**ASHLAND PLANNING COMMISSION  
REGULAR MEETING  
JANUARY 10, 2011  
AGENDA**

**A. PLANNING ACTION: #2011-01576**

**SUBJECT PROPERTY: 1554 Webster Street** (*on the Southern Oregon University campus*)

**ASHLAND PLANNING DIVISION  
STAFF REPORT ADDENDUM  
January 10<sup>th</sup>, 2012**

Derrick: Please do computer scale drawings  
 Suggested Modifications to Proposed  
 SOC Dorms

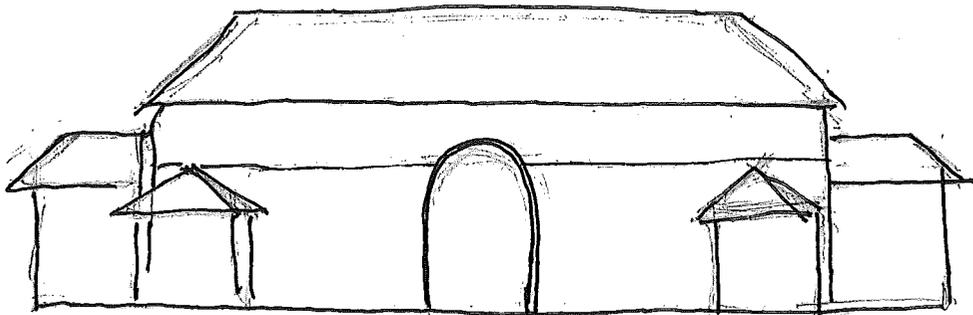
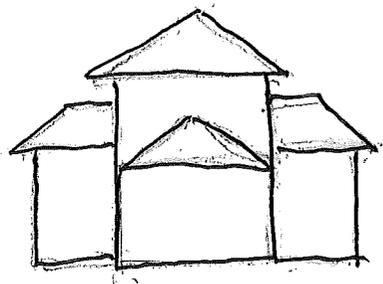
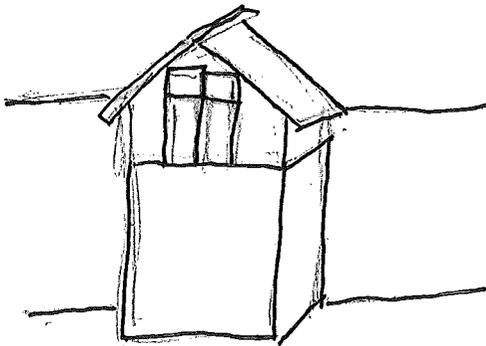
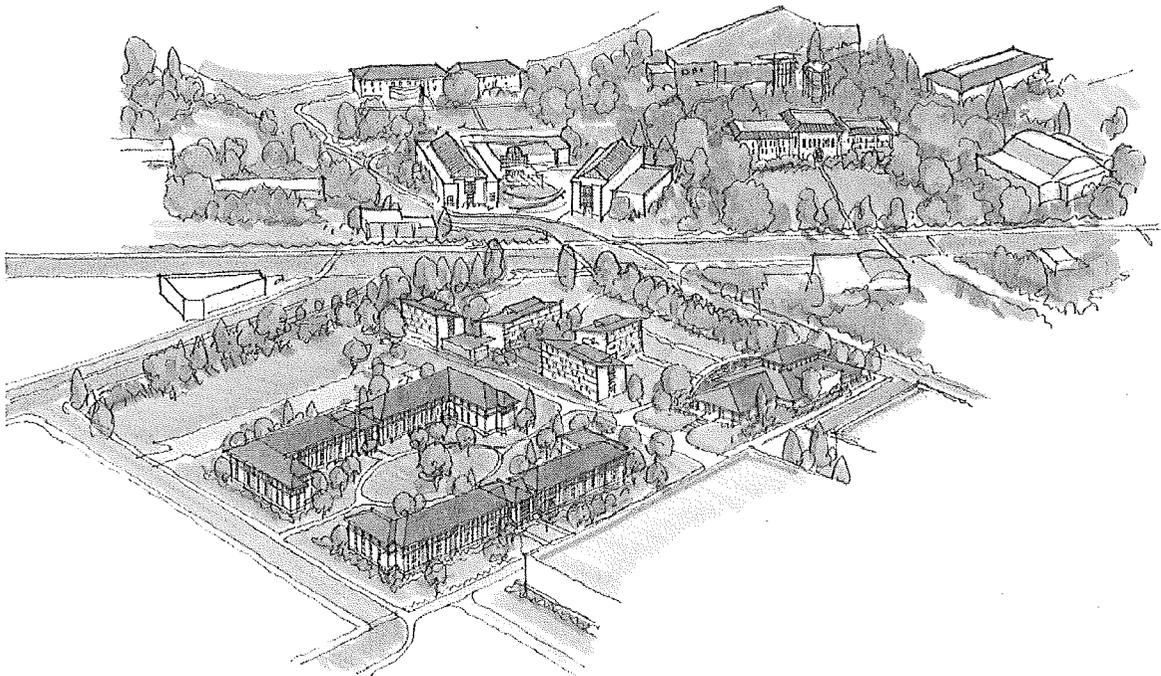
(THIS IS DORM ACROSS FROM GYM, REVERSE PLAN OPPOSITE DORM)

GABLE BAY  
 (INSTEAD OF HIP)

**L001**

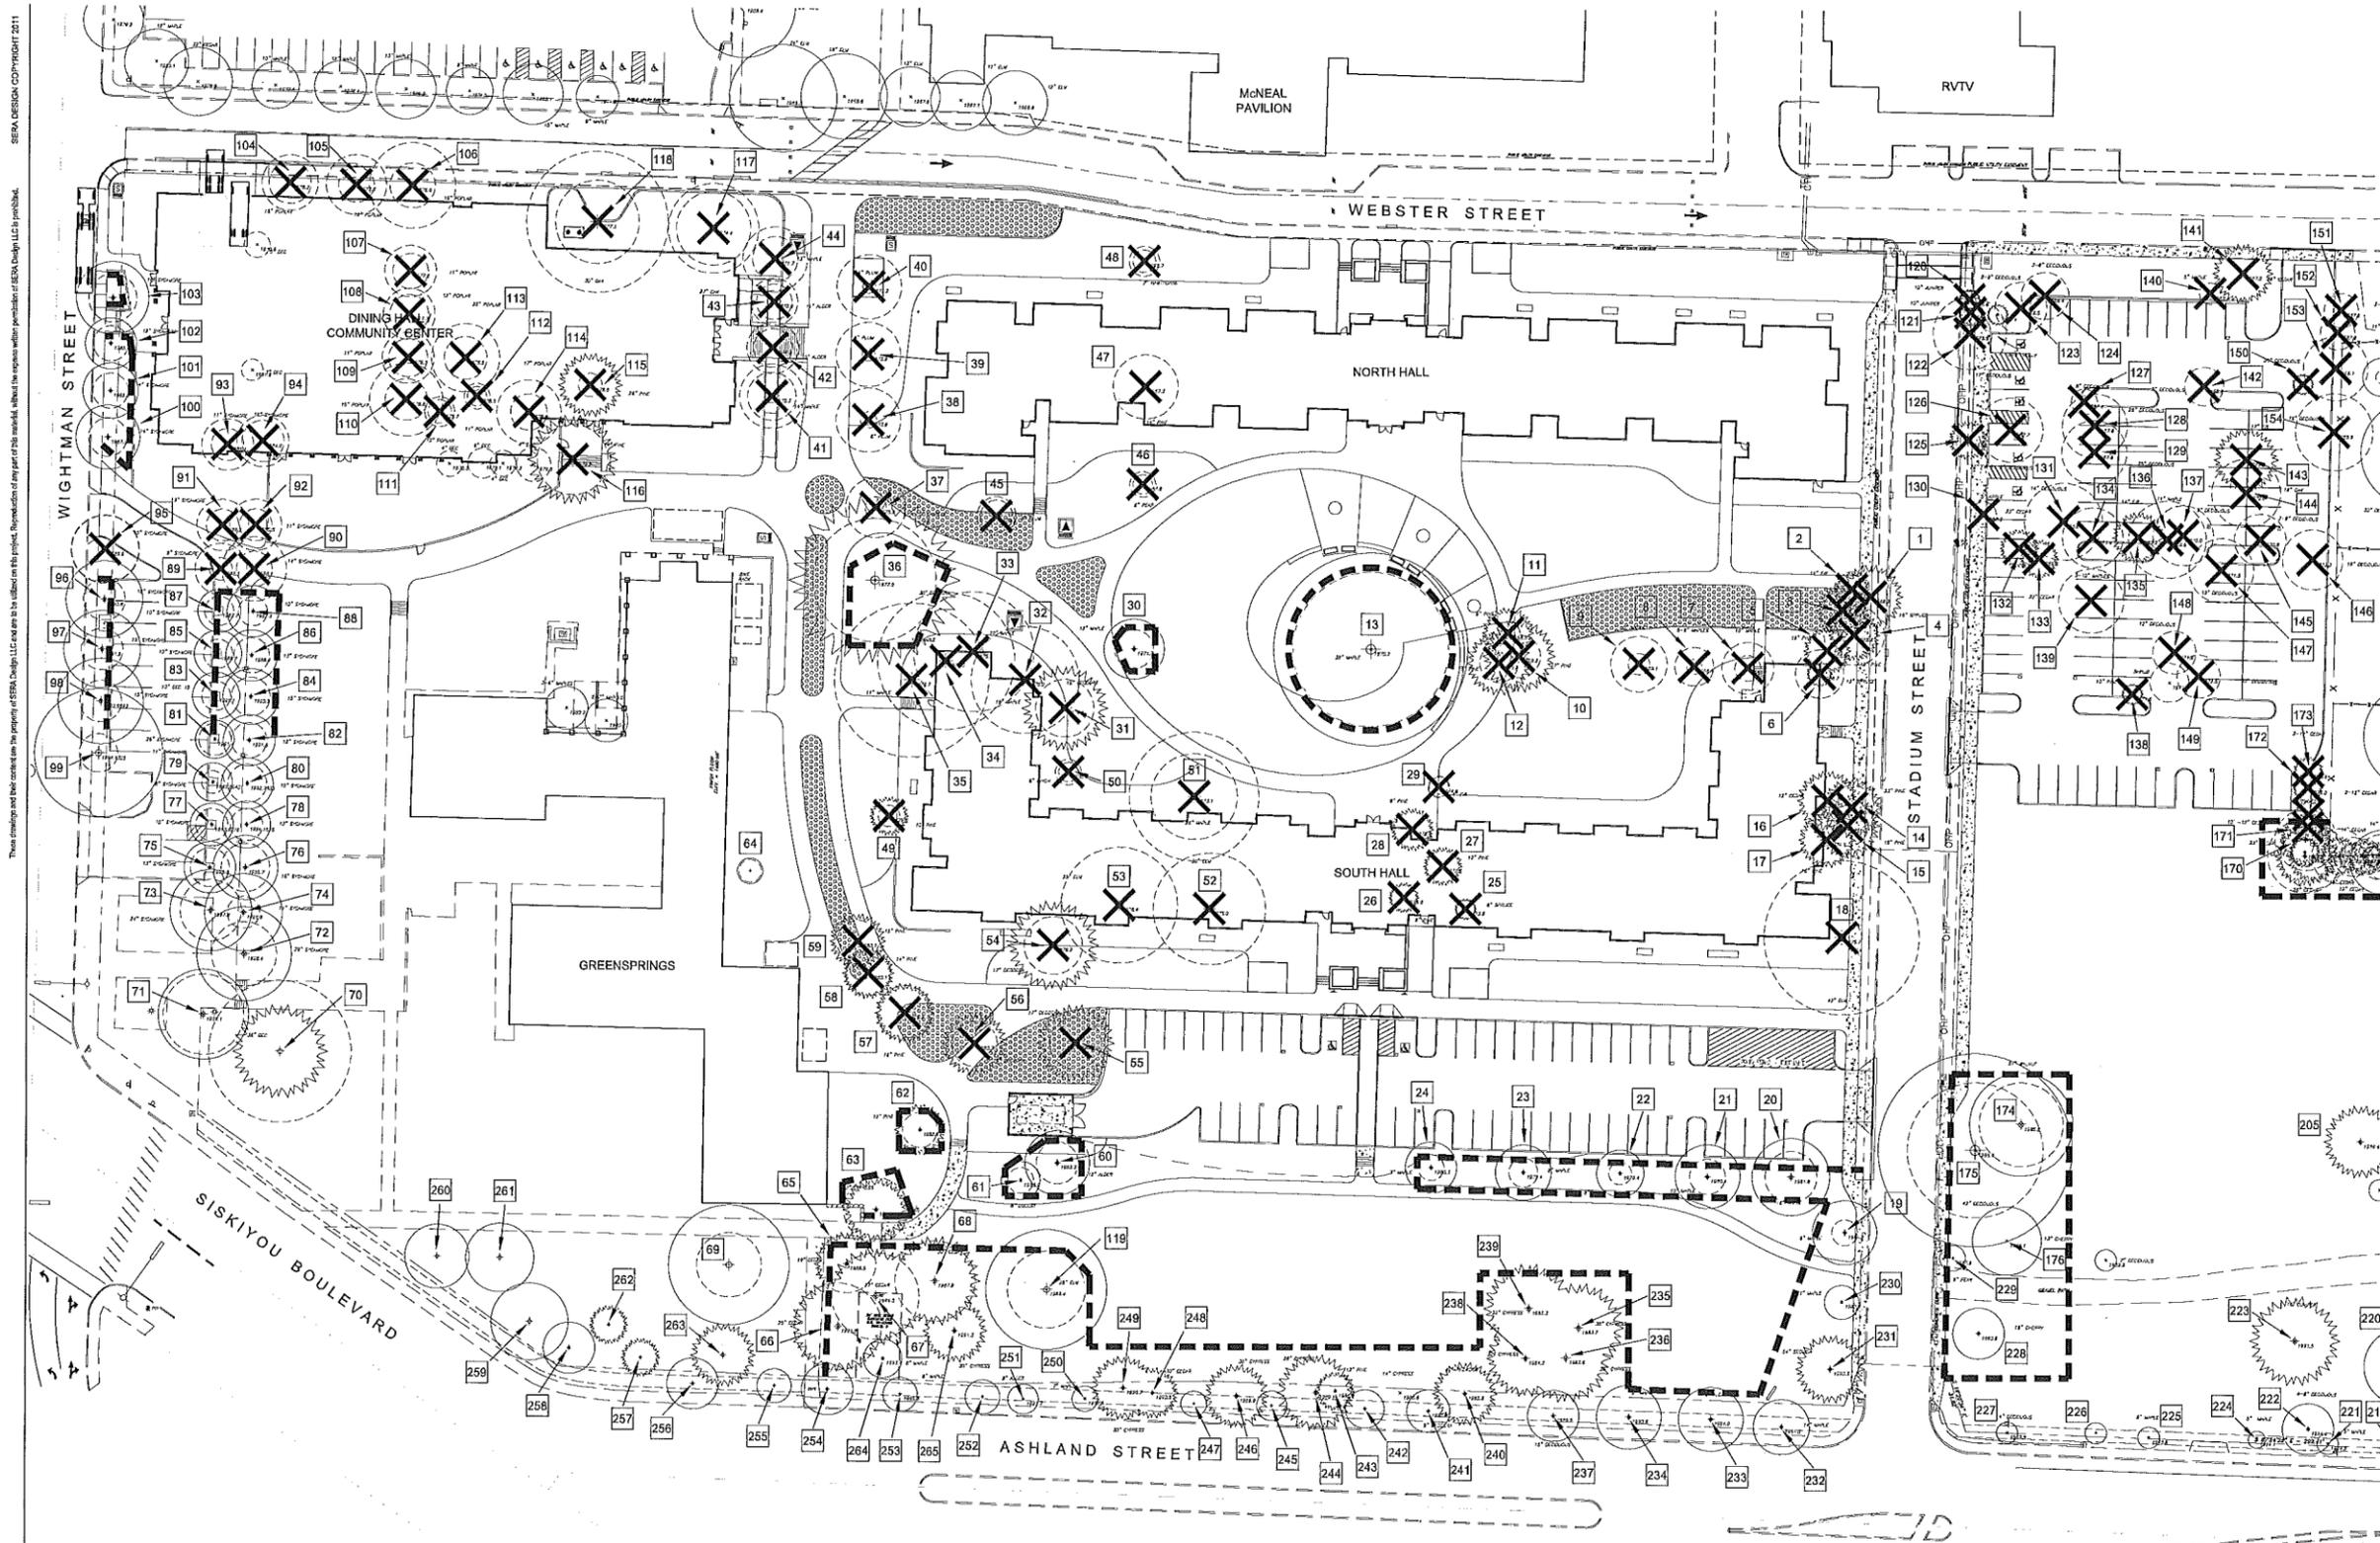
Staff has discussed this issue at some length with the applicants subsequent to the December meetings of the Planning and Transportation Commissions, and believe the more appropriate treatment to accommodate pedestrian circulation in this vicinity until a building is developed along Ashland Street is to require that a new off-street pedestrian connection which would link the existing pathway system from the gateway intersection and Greensprings dorms through the grassy area along Ashland Street, through the parking along South College Way with a materially-distinct crossing to the entrance of the proposed South Hall and out to the sidewalk on Ashland Street near its intersection with Stadium Street and the crosswalk leading to the nearby University District. This pathway would provide a more direct route to the most likely pedestrian destinations arising from the shifting of the resident population to the north campus in a manner which would be better integrated into the existing campus pedestrian circulation system, and would also accommodate coordinated planning of sidewalk improvements with future development at the street. The applicants have provided a revised Landscaped Site Plan (Sheet L001 revised December 30, 2011) which details this pathway installation.

**Stadium Street/Ashland Street**

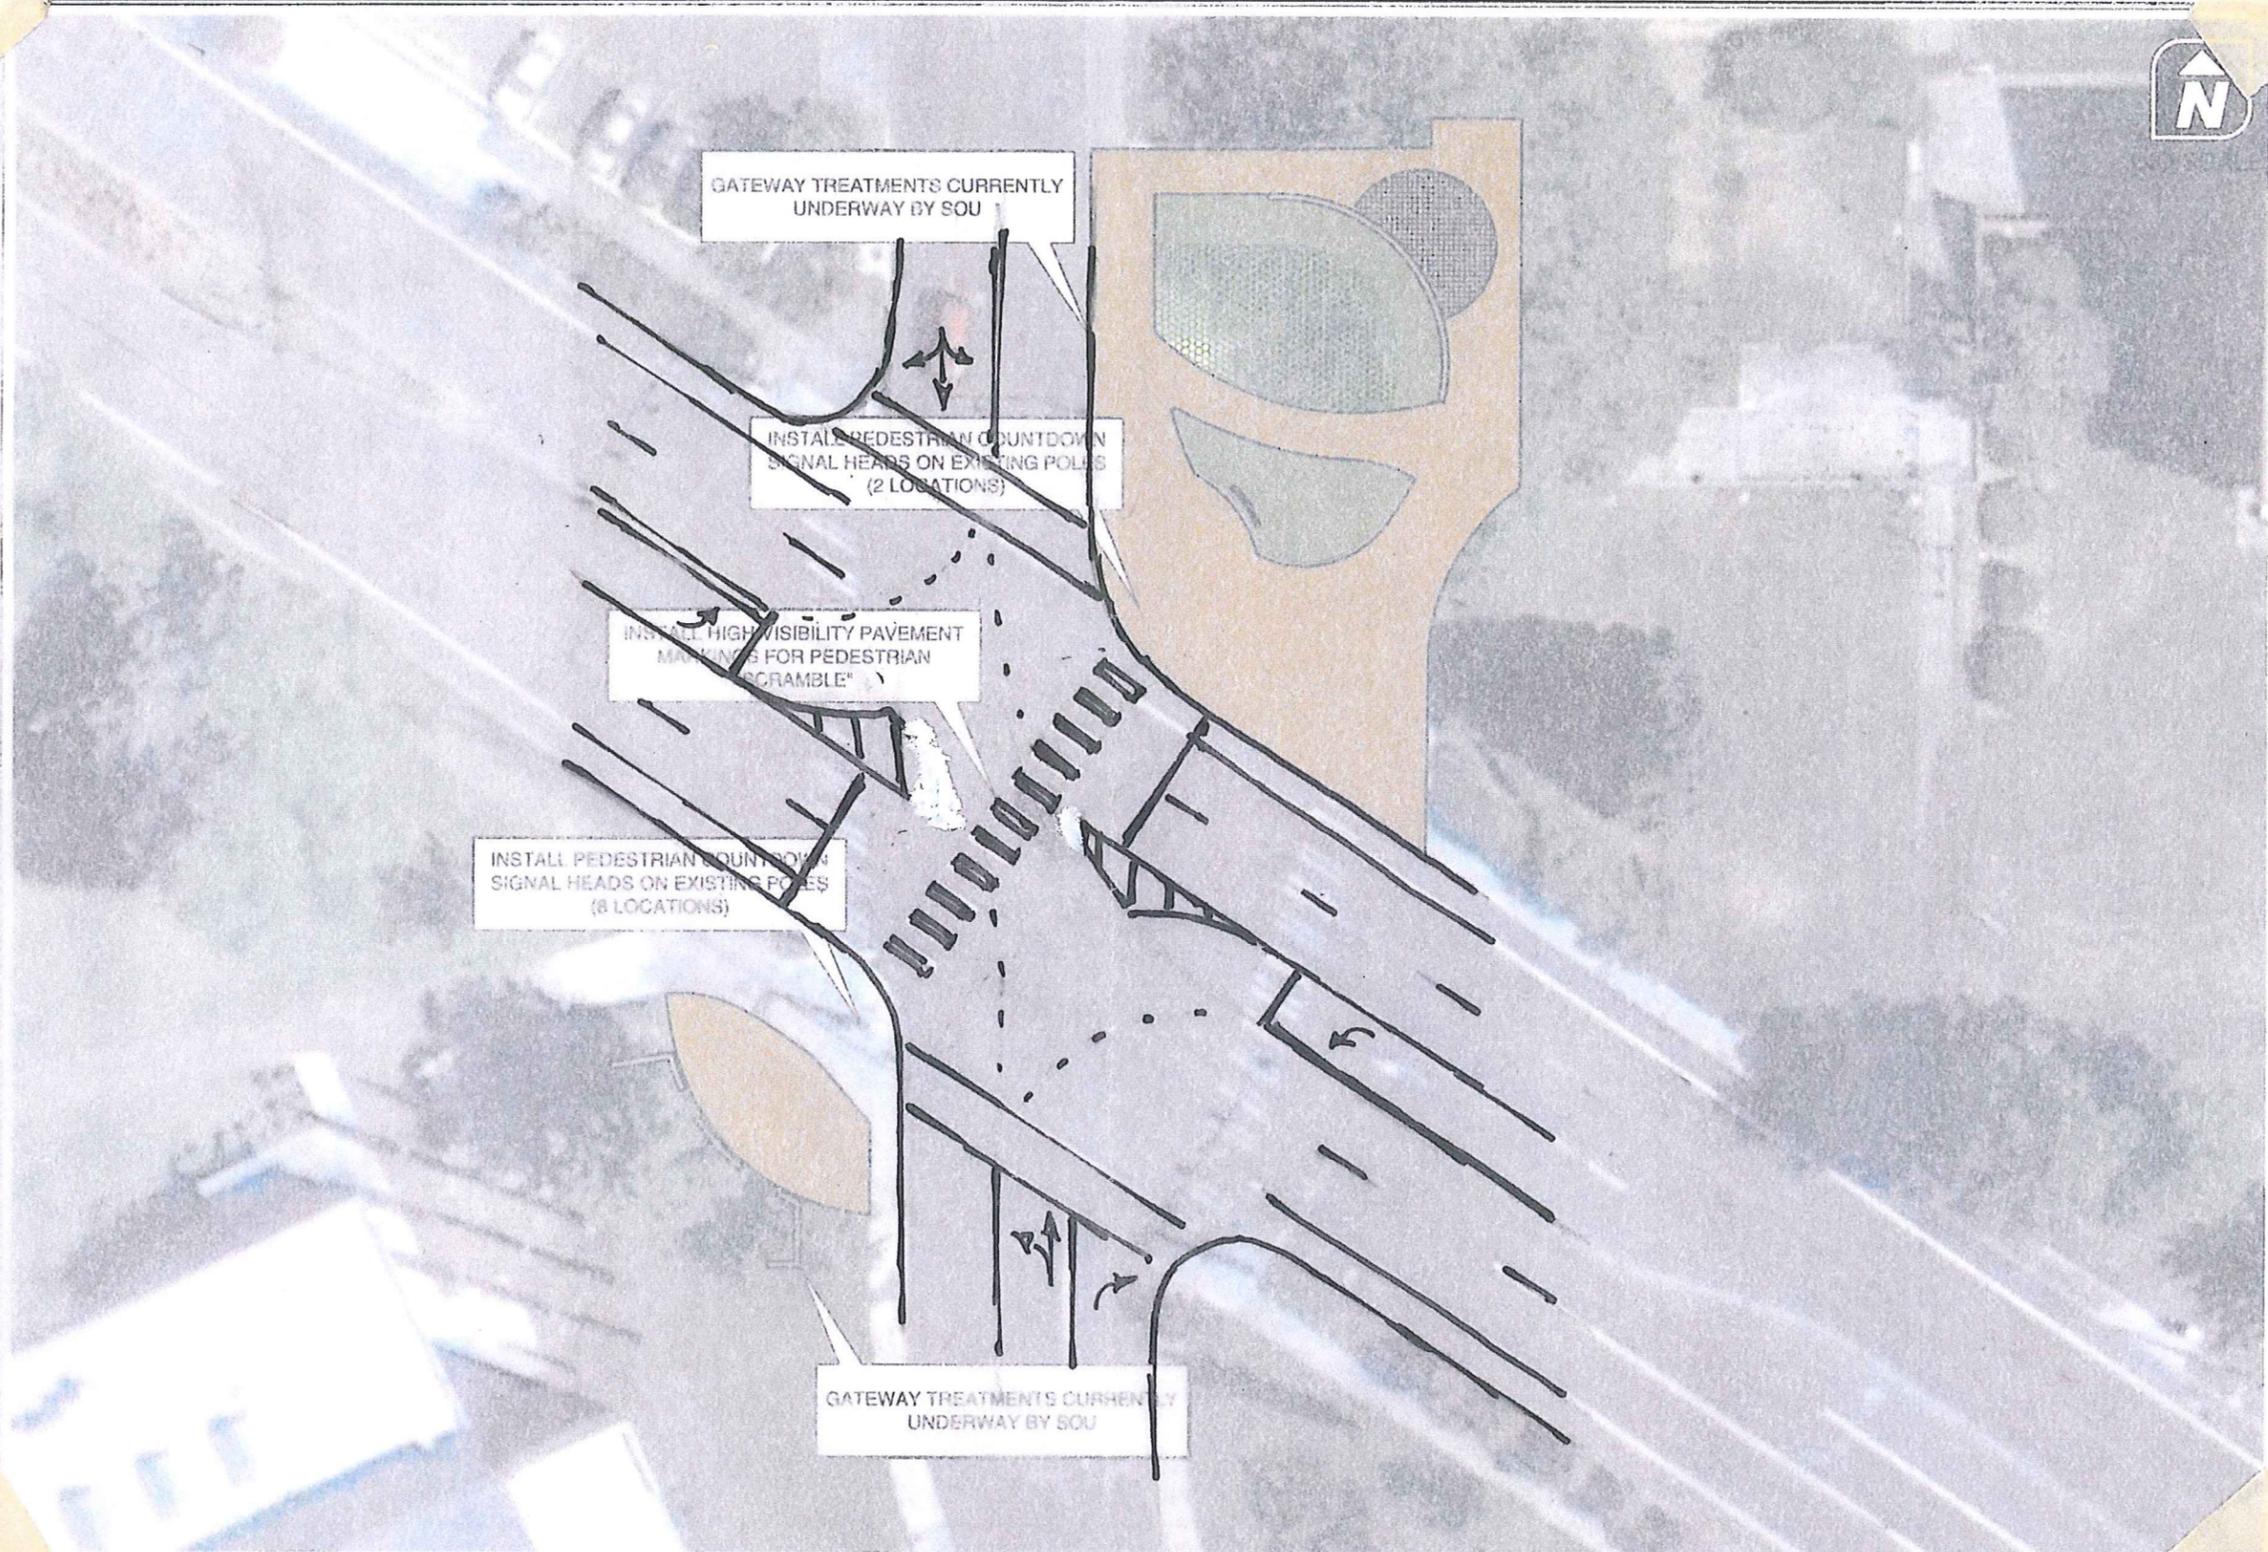
- 1) Install advance pedestrian signs
- 2) Install Audible Rectangular Rapid Flash Beacons
- 3) Review location of existing crosswalk, and if conditions warrant relocate crosswalk with appropriate pedestrian ways and pedestrian amenities from the new facility

- 1) Replace Pedestrian Heads with Audible Pedestrian Countdown Heads
- 2) Provide a 5 second leading pedestrian phase
- 3) Pedestrian amenities on SOU campus frontage
